# INTERNATIONAL STANDARD

AMENDMENT 2

**Information technology – Generic cabling for customer premises**

**Figure 11 – Example of a system showing the location of cabling interfaces and extent of associated channels**

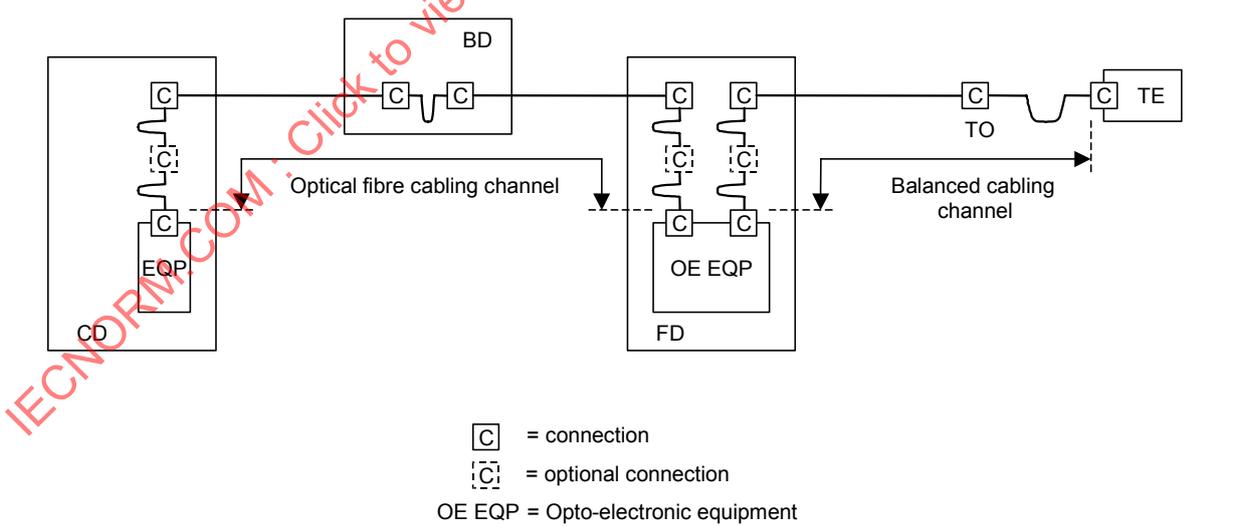
Replace, in ISO/IEC 11801:2002, the existing paragraph prior to Figure 11, as well as Figure 11 by the following:

Figure 11 shows an example of terminal equipment in the work area connected to transmission equipment using two different media channels which are cascaded. In fact, there is an optical fibre cabling channel (see Clause 8) connected via an active component in the FD to a balanced cabling channel. There are four channel interfaces; one at each end of the balanced channel and one at each end of the optical fibre cabling channel.

Figure 12 – Horizontal cabling models

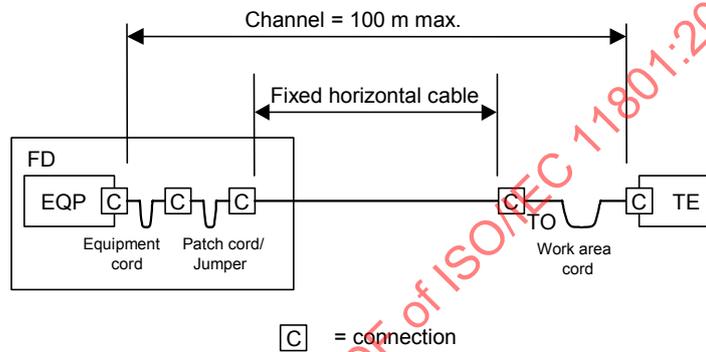
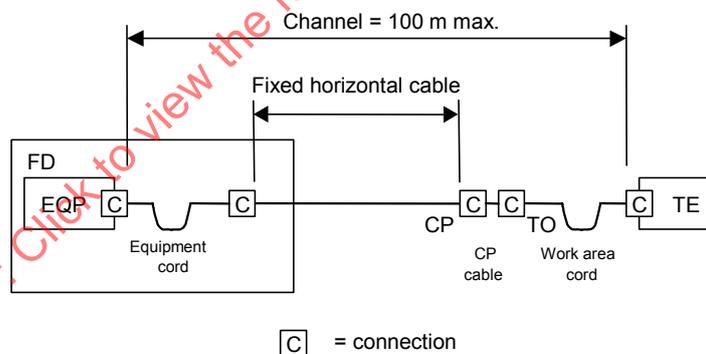
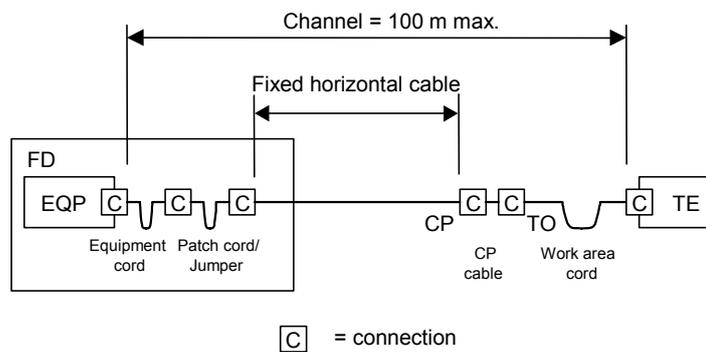
*Replace, in ISO/IEC 11801:2002, the existing Figure 12 by the following:*

Figure 14 – Combined backbone/horizontal channels

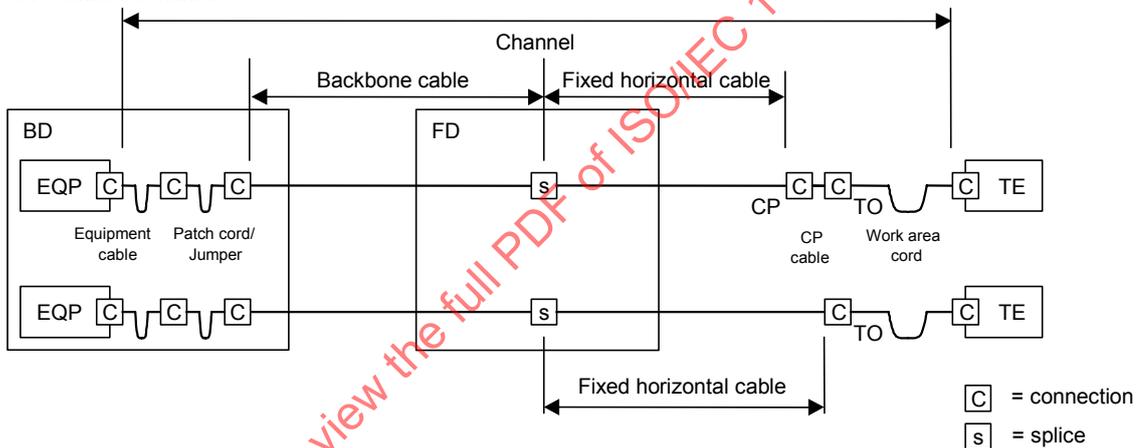
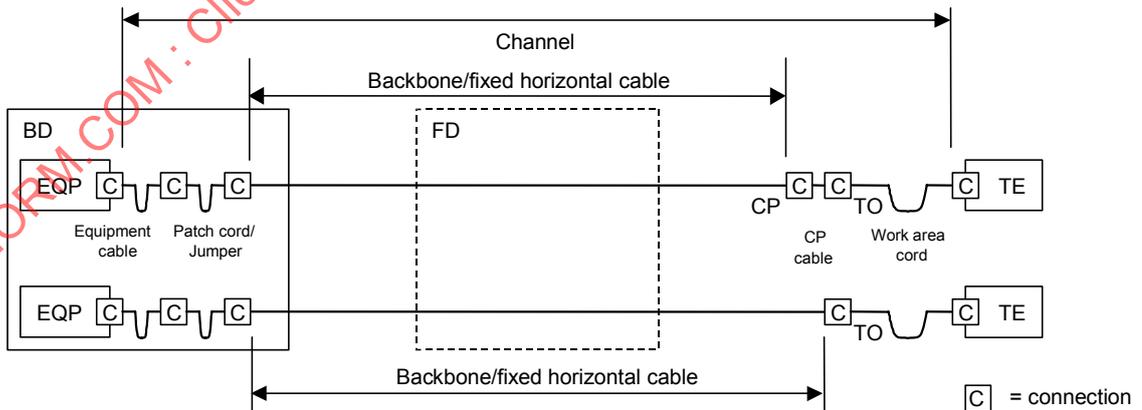
Replace, in ISO/IEC 11801:2002, the existing Figure 14 by the following:

**Figure 15 – Pin grouping and pair assignments for IEC 60603-7 series interface for Categories 5, 6 and 6<sub>A</sub> (front view of fixed connector (jack), not to scale)**

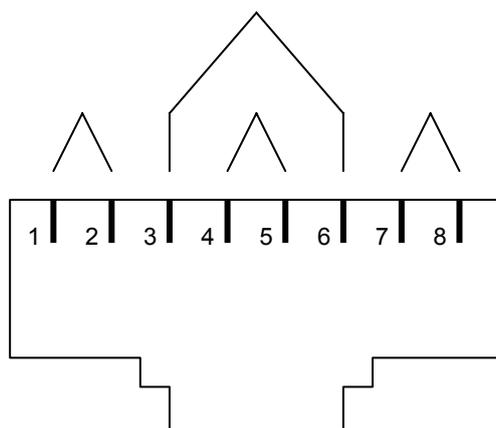
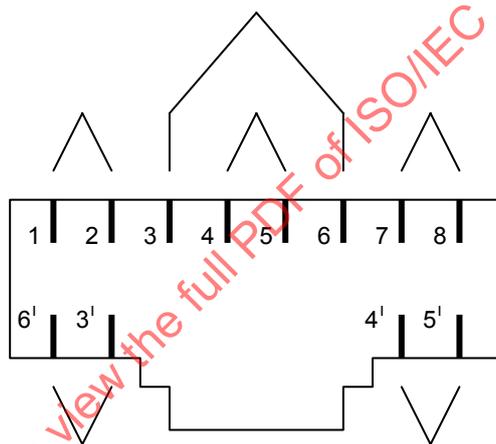
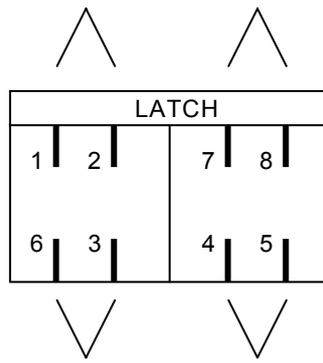
Replace, in ISO/IEC 11801:2002, the title and the entire text including Figure 15 and Table 45 (renumbered as Table 56 by Amendment 1:2008) by the following:

For all cabling classes, each horizontal balanced cable shall be terminated at the telecommunications outlet with an unkeyed fixed connector (jack) that meets the specifications of 10.2.3 and 10.2.4. Pin and pair grouping assignments shall be as shown in Figures 15, 18 or 19.

**Figure 20 – Duplex-able LC connectivity configuration with an example of polarity identification**

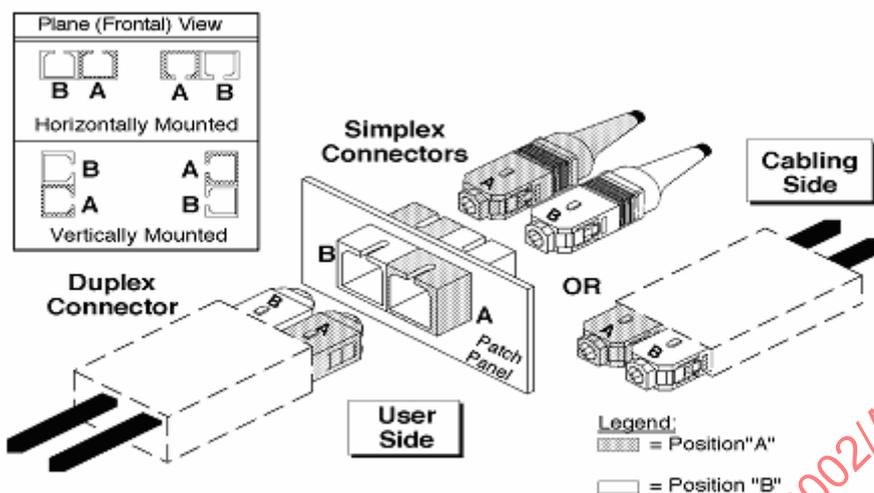
Replace, in ISO/IEC 11801:2002, the entire text and Figure 16 by the following:

Where there is no installed base of optical fibre cabling, the LC connectivity is specified at the TO and should provide a means to identify the polarity by any combination of latching, keying, or labelling. See an example in Figure 20.

Where premises have an installed base of SC-D connectivity, additional TO connections may be made using SC-D connectivity provided their keys are oriented as in Figure 16.

**Figure A.1 – Link options**

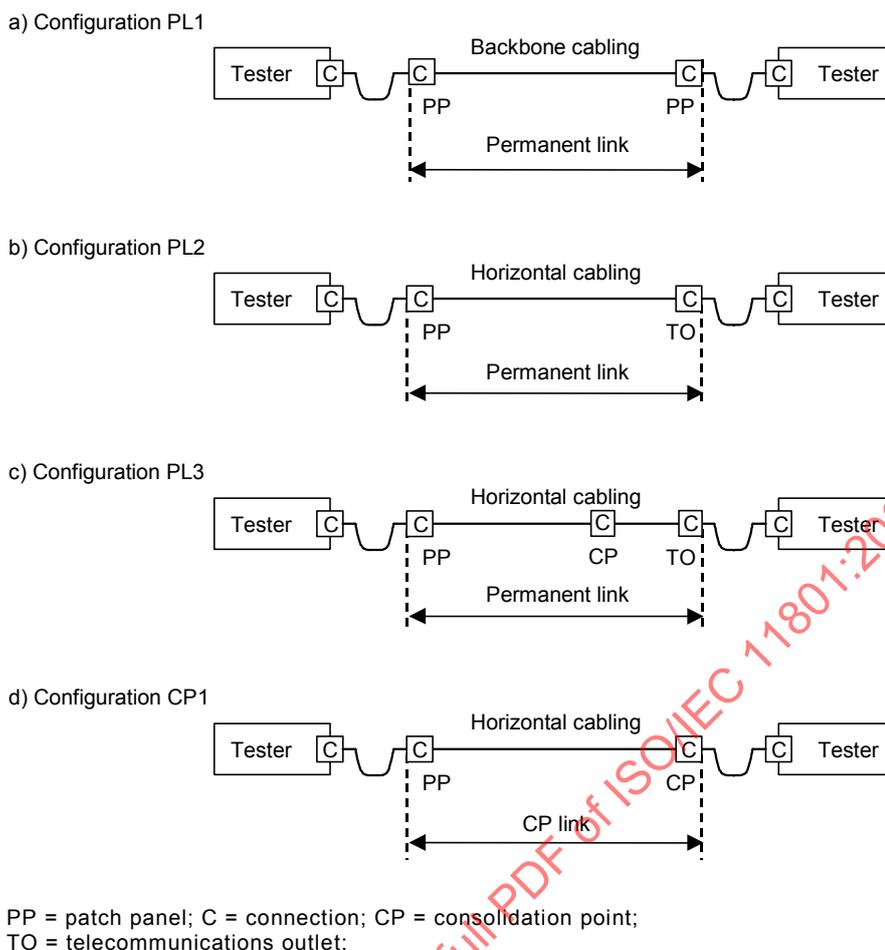
*Replace, in ISO/IEC 11801:2002, the entire text, including figures and tables, of this annex by the following:*

This annex contains performance requirements for balanced permanent links and CP links as shown in Figure A.1.

The cabling under test in configurations PL1, PL2 and PL3 is termed the permanent link. The configurations PL1 and PL2 comprise fixed cabling only. Configuration PL3 comprises fixed cabling and a CP cable between the CP and the TO. If the CP cable is changed, performance of this configuration will change. The cabling under test in configuration CP1 contains fixed cabling only and is termed the CP link. The difference between the CP link and the PL2 link is that the CP link is assumed to be extended, in the future, to a permanent link by the addition of cabling components. The difference between PL2 and PL3 specifications are related to the mathematical model length assumptions of Table 31<sup>16</sup>, and the addition of cords to create a channel.

Figure E.2 – Examples of cable types

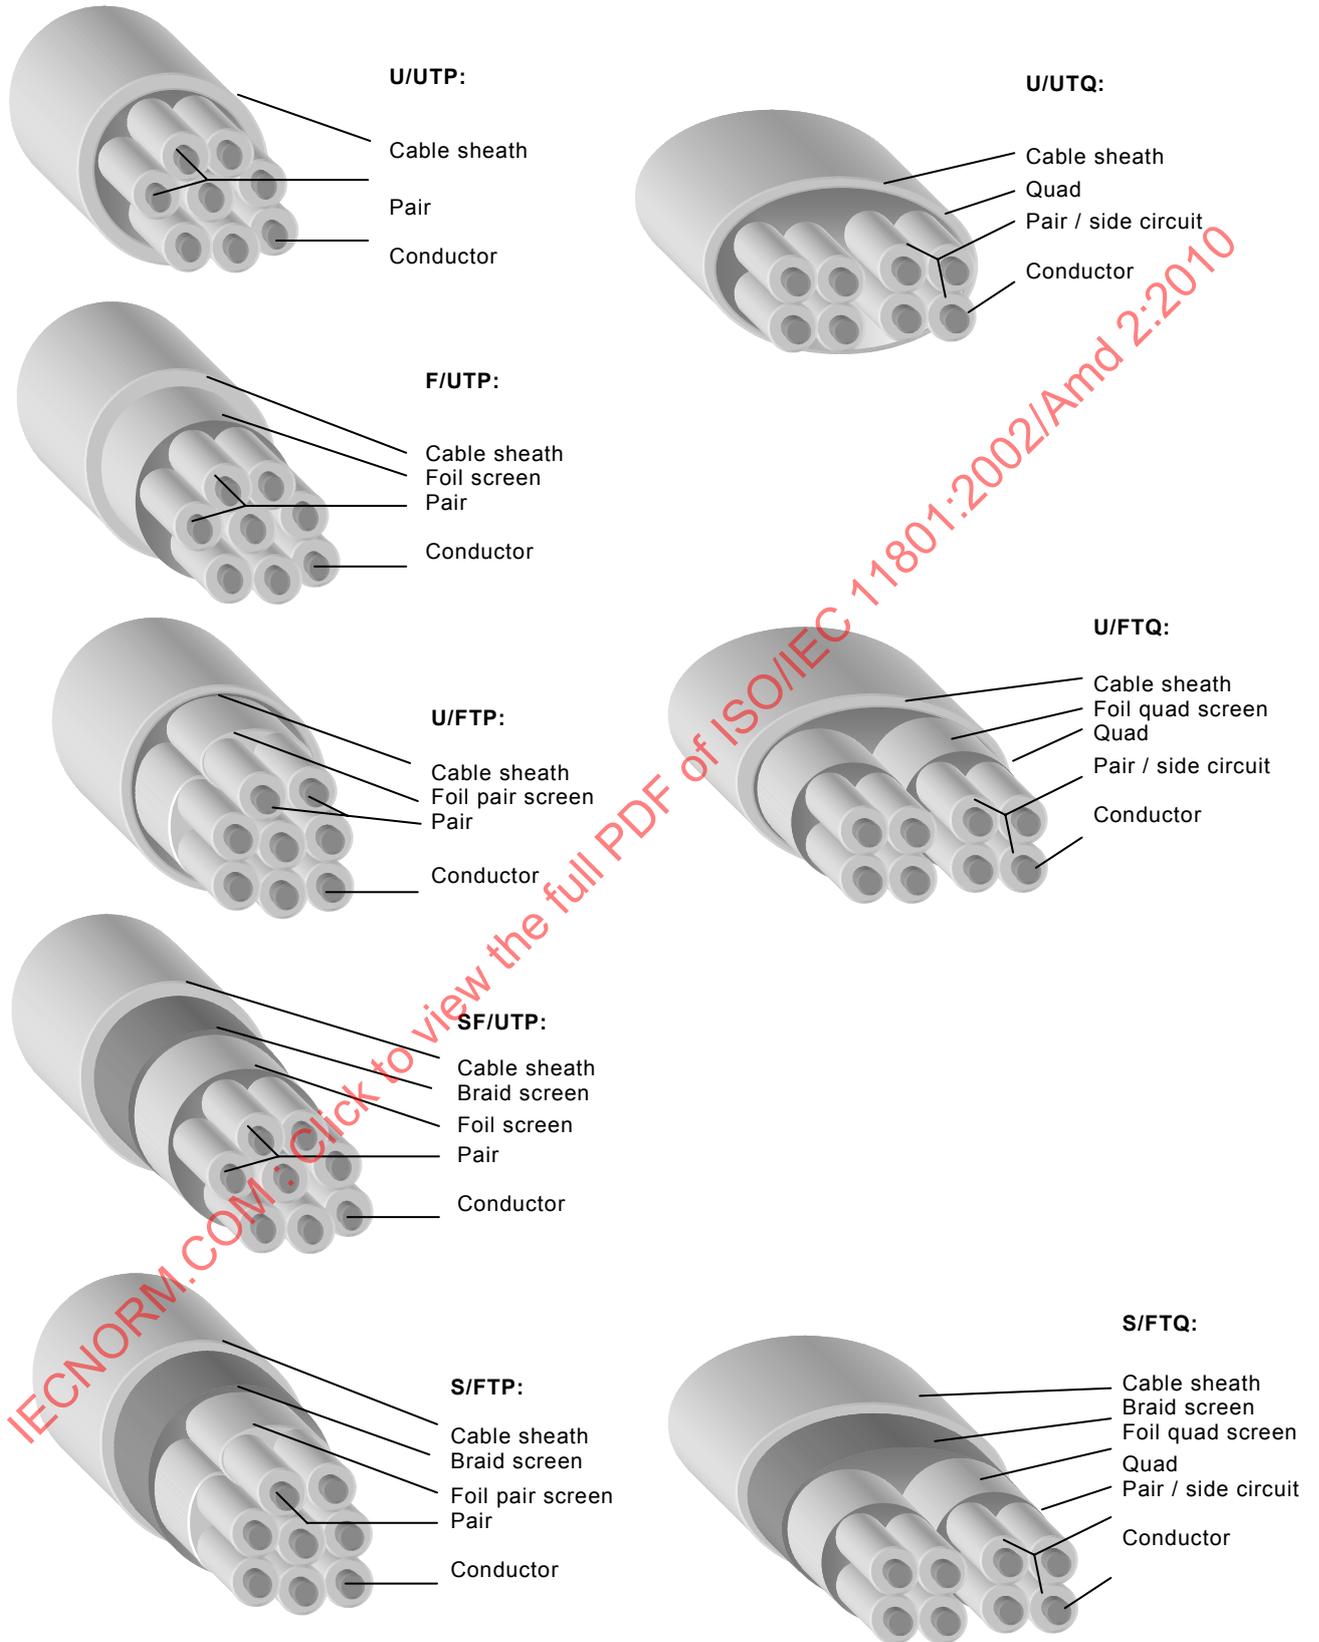
Replace, in ISO/IEC 11801:2002, the existing Figure E.2 by the following:
